SOURCE: CHAIRMAN OF THE SPECIALISTS GROUP  
TITLE : REPORT OF THE SEVENTEENTH MEETING IN TOKYO (November 7 - 10, 1989)

Fig. X

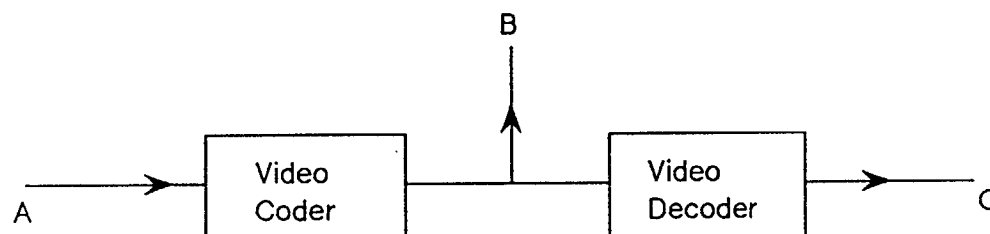
Point A is the video input to the video coder. Point B is the channel output from the video terminal (i.e. including any FEC, channel framing etc.).

Point C is the video output from the decoder.

A video sequence lasting more than 100 seconds is connected to the video coder input (point A) in Figure X above. The video sequence should have the following characteristics.

The encoder delay is obtained by measuring the time from when the visible identification changes at point A to the time that the change is detected at point B. Similarly, the decoder delay is obtained by taking measurements at points B and C.

The meeting approved to include this outcome in the final Recommendation.
